SYDNEY CENTRAL CITY PLANNING PANEL

COUNCIL ASSESSMENT REPORT

Panel Reference	2017SWC087
DA Number	DA/560/2017
LGA	City of Parramatta Council
Proposed Development	Construction of a 48 storey mixed use tower comprising 382 residential units, 646sqm of retail floor space, 5354sqm of office floor space and 8 basement levels containing space for 237 cars, 223 bicycles, 18 motorcycles, storage, refuse and servicing; following demolition of existing buildings. The application is Nominated Integrated development under the Water Management Act 2000 and the National Parks and Wildlife Act 1974.
Street Address	7 Charles Street and 116 Macquarie Street, Parramatta (Lots 3 & 4 DP17466, Lot 12 DP706694)
Applicant	Statewide Planning Pty Ltd
Owner	Merchant Power Pty Ltd
Date of DA lodgement	29 June 2017
Number of Submissions	Five (5)
Recommendation	Approval subject to conditions
Regional Development Criteria (Schedule 4A of the EP&A Act)	Pursuant to Clause 3 of Schedule 4A of the Environmental Planning and Assessment Act 1979 (at the time of lodgement), the development has a capital investment value of more than \$20 million.

Report prepared by	Alex McDougall Executive Planner, City Significant

Figure 8. Extract from Landscape Report depicting Southern Forecourt (Orange is the residential forecourt, yellow is retail forecourt, blue represents the awning over).

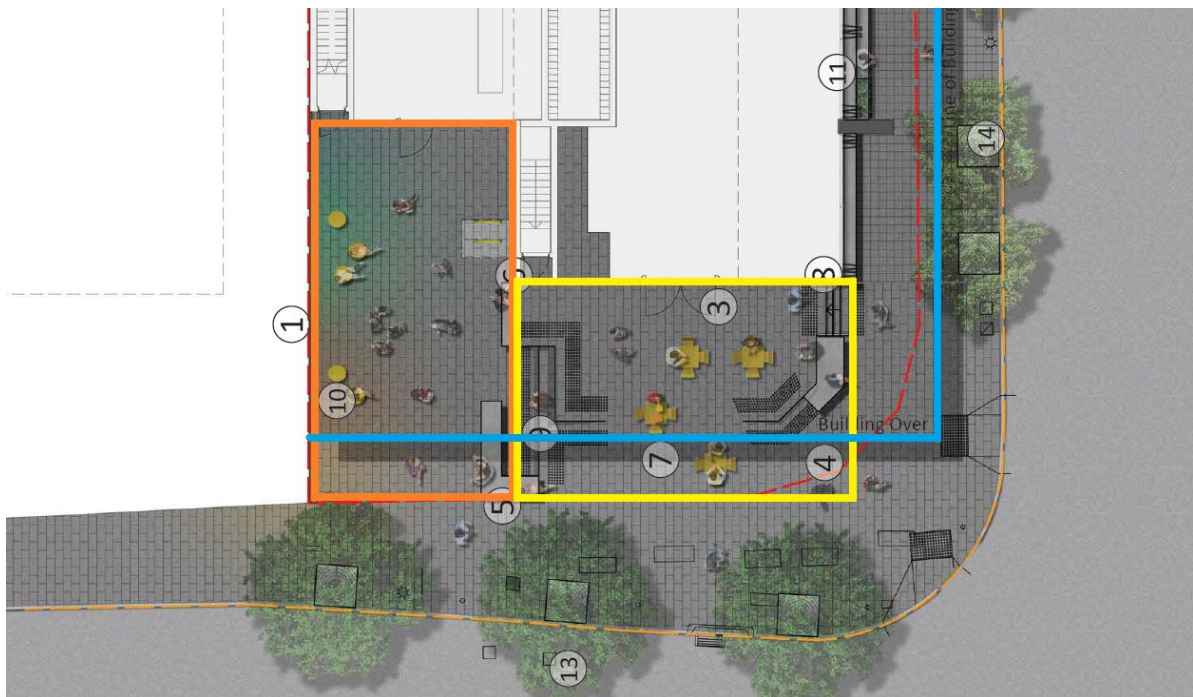
At a preliminary briefing, the Sydney Central City Planning Panel raised concern that the level of street activation was not adequate and raised particular concern that:

- a) The poor streetscape outcome on Charles Street resulting from the proposed unbroken servicing area to the north of the site consisting of the substation, servicing area and driveway (see Figure 7 below); and
- b) The lack of pedestrian amenity at the southern Macquarie Street forecourt due to lack of solar access and high winds.

As outlined in Figure 8 below, the southern forecourt is composed of a residential forecourt and retail forecourt. The applicant has indicated that the retail forecourt could be used as an outdoor seating space for a potential future café/restaurant in the adjacent unit.

While overshadowed for most of the day, the level of activation of the Macquarie Street forecourt is considered to be acceptable for the following reasons:

- The area is protected by an awning which will provide wind and rain protection to the occupants of the forecourt.
- The preliminary public art plan outlines the provision of a perforated pattern wall on the western wall which encloses this space (see Figure 9 below).
- The alternative is no southern forecourt which would require the building be longer, which is an undesirable outcome.
